TRANSMITTAL OF CERTIFICATION STATEMENT FOR THE CLASS 2 RESOURCE CONSERVATION AND RECOVERY ACT PERMIT (PERMIT) MODIFICATIONS AND REQUEST FOR TEMPORARY AUTHORIZATION AT THE 183-H SOLAR EVAPORATION UNIT (TSD: T-1-4)

**PROPOSED CLASS 2 RESOURCE CONSERVATION AND RECOVERY ACT (RCRA)  
PERMIT MODIFICATIONS AND REQUEST FOR TEMPORARY AUTHORIZATION AT  
THE 183-H SOLAR EVAPORATION UNIT (TSD: T-1-4)**

**Class 2 modification to the Hanford Facility Dangerous Waste Permit, Revision 8C and a red line strike out of Chapter 3.0, Groundwater Monitoring for the 183-H Solar Evaporation Unit pursuant to WAC 173-303-830(4)(b)**

**Part VI, Closure Unit 2  
183-H Solar Evaporation Basins**

9 **Figure 3.1. Location Map for 100-H Area Monitoring Wells**

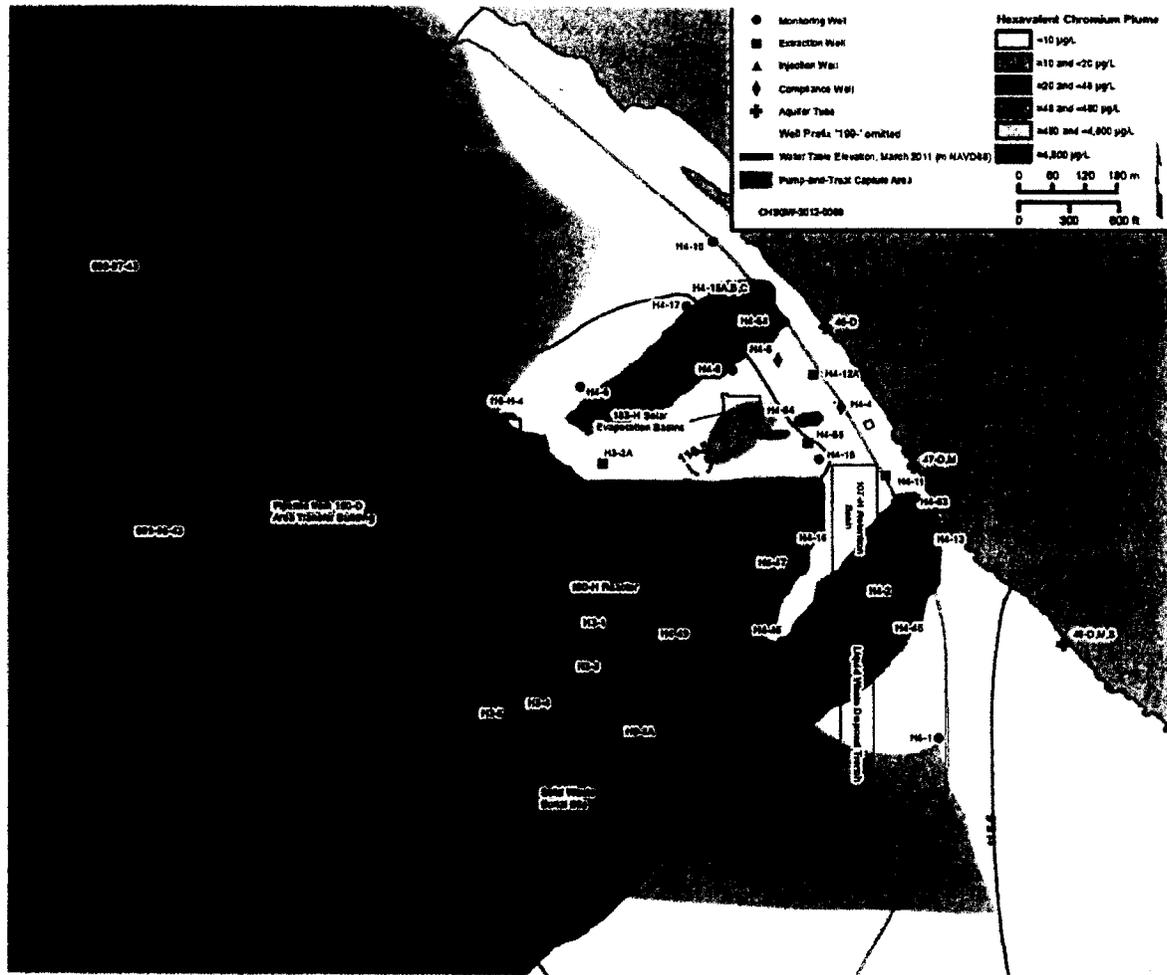
<b>Hanford Facility RCRA Permit Modification Notification Form</b>														
Unit: <b>183-H Solar Evaporation Basins</b>	Permit Part <b>Part VI, Post Closure Unit 2</b>													
<p><u>Description of Modification:</u> Chapter 3.0, Figure 3.1:</p> <p style="text-align: center;"><b>Figure 3.1. Location Map for 100-H Area Monitoring Wells</b></p> <p>Changes to this figure have been made to maintain consistency with Section 3.2</p>														
<p>WAC 173-303-830 Modification Class <sup>1 2</sup></p> <table border="1" style="width: 100%; border-collapse: collapse;"> <tr> <td style="width: 50%; padding: 2px;">Please mark the Modification Class:</td> <td style="width: 10%; padding: 2px;">Class 1</td> <td style="width: 10%; padding: 2px;">Class <sup>1</sup></td> <td style="width: 10%; padding: 2px;">Class 2</td> <td style="width: 10%; padding: 2px;">Class 3</td> </tr> <tr> <td style="padding: 2px;"></td> <td style="padding: 2px;"></td> <td style="padding: 2px;"></td> <td style="padding: 2px; text-align: center;">X</td> <td style="padding: 2px;"></td> </tr> </table>					Please mark the Modification Class:	Class 1	Class <sup>1</sup>	Class 2	Class 3				X	
Please mark the Modification Class:	Class 1	Class <sup>1</sup>	Class 2	Class 3										
			X											
<p>Enter relevant WAC 173-303-830, Appendix I Modification citation number: C.1.a            Enter wording of WAC 173-303-830, Appendix I Modification citation:            Changes in the number, location, depth, or design of upgradient or downgradient wells of permitted groundwater monitoring system. Removal of well 199-H4-3 from the RCRA groundwater monitoring network and replacement with 199-H4-84 reflects changes made during 2011 remedial investigation activities. Well 199-H4-3 needs to be decommissioned, because it interferes with the 100H Area waste sites excavation footprint. Well 199-H4-84 is closer to the waste site and should better represent groundwater conditions. The CERCLA pump &amp; treat system is connected to 199-H4-12C, not 199-H4-12A. Well 199-H4-12A is completed in the unconfined aquifer, where hexavalent chromium concentrations are low. Well 199-H4-12C is completed in the confined aquifer within Ringold Upper Mud unit, where hexavalent chromium concentrations were found to be above 100 ppb. Well H4-7 is being removed from the figure to reflect its scheduled decommissioning from the CERCLA interim action network to support vadose zone remediation activities in the 100-H Area. The figure is also being updated to current DOE and CHPRC cartographic standards (river arrows, color changes, legend changes, etc.). Changes to the figure reflect the operation of the new HX pump and treat system and revisions to the CERCLA and RCRA monitoring networks.</p>														
<p>Modification Approved: <input type="checkbox"/> Yes <input type="checkbox"/> No (state reason for denial)</p> <p><u>Reason for denial:</u></p>			<p>Reviewed by Ecology:</p>											
			<p style="text-align: center;">N. Menard _____ Date _____</p>

Figure 3.2. Predicted Groundwater Flow During Interim Remedial Measure

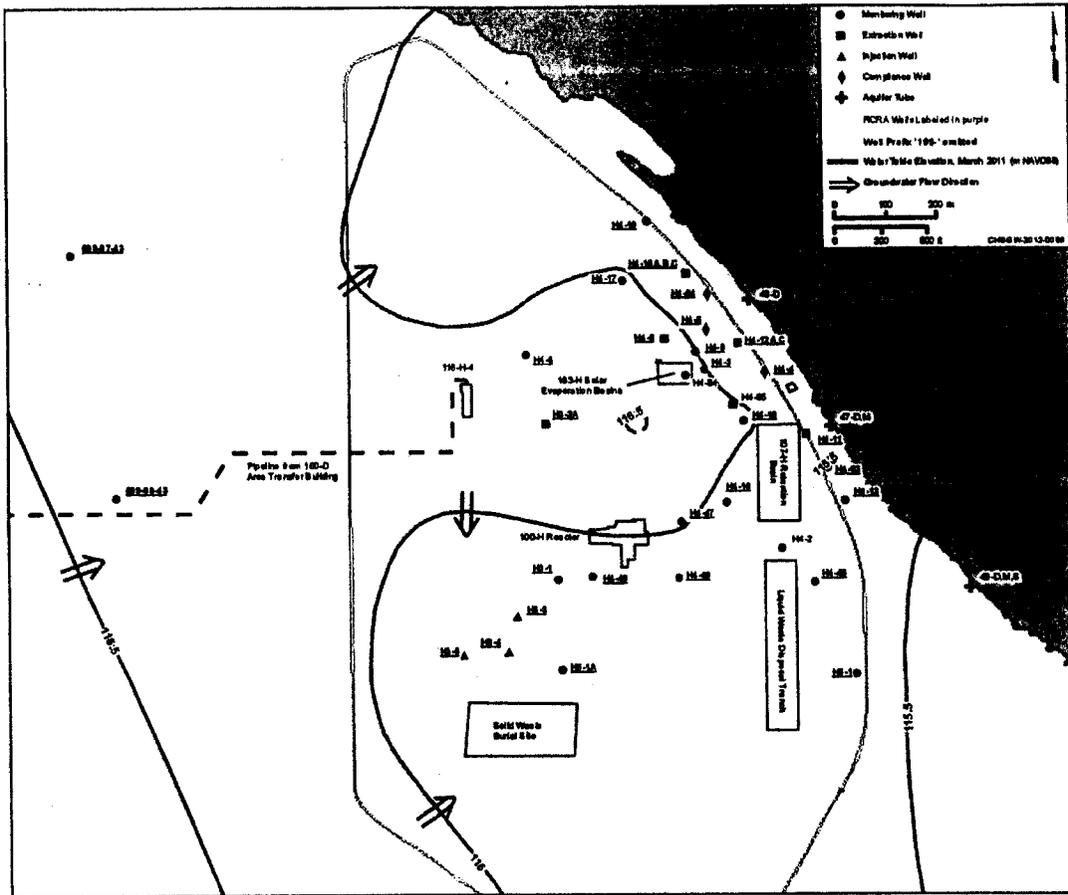
<b>Hanford Facility RCRA Permit Modification Notification Form</b>					
Unit: <b>183-H Solar Evaporation Basins</b>	Permit Part <b>Part VI, Post Closure Unit 2</b>				
<p><u>Description of Modification:</u> Chapter 3.0, Figure 3.2:</p> <p style="text-align: center;"><b>Figure 3.2. Location Map for 100-H Area Monitoring Wells</b></p> <p>Changes to this figure have been made to maintain consistency with Section 3.2</p>					
WAC 173-303-830 Modification Class <sup>1 2</sup>		Class 1	Class <sup>1</sup>	Class 2	Class 3
Please mark the Modification Class:				X	
<p>Enter relevant WAC 173-303-830, Appendix I Modification citation number: C.1.a  Enter wording of WAC 173-303-830, Appendix I Modification citation:  Changes in the number, location, depth, or design of upgradient or downgradient wells of permitted groundwater monitoring system. Removal of well 199-H4-3 from the RCRA groundwater monitoring network and replacement with 199-H4-84 reflects changes made during 2011 remedial investigation activities. Well 199-H4-3 needs to be decommissioned, because it interferes with the 100H Area waste sites excavation footprint. Well 199-H4-84 is closer to the waste site and should better represent groundwater conditions. The CERCLA pump &amp; treat system is connected to 199-H4-12C, not 199-H4-12A. Well 199-H4-12A is completed in the unconfined aquifer, where hexavalent chromium concentrations are low. Well 199-H4-12C is completed in the confined aquifer within Ringold Upper Mud unit, where hexavalent chromium concentrations were found to be above 100 ppb. Well H4-7 is being removed from the figure to reflect its scheduled decommissioning from the CERCLA interim action network to support vadose zone remediation activities in the 100-H Area. The figure is also being updated to current DOE and CHPRC cartographic standards (river arrows, color changes, legend changes, etc.). Changes to the figure reflect the operation of the new HX pump and treat system and revisions to the CERCLA and RCRA monitoring networks.</p>
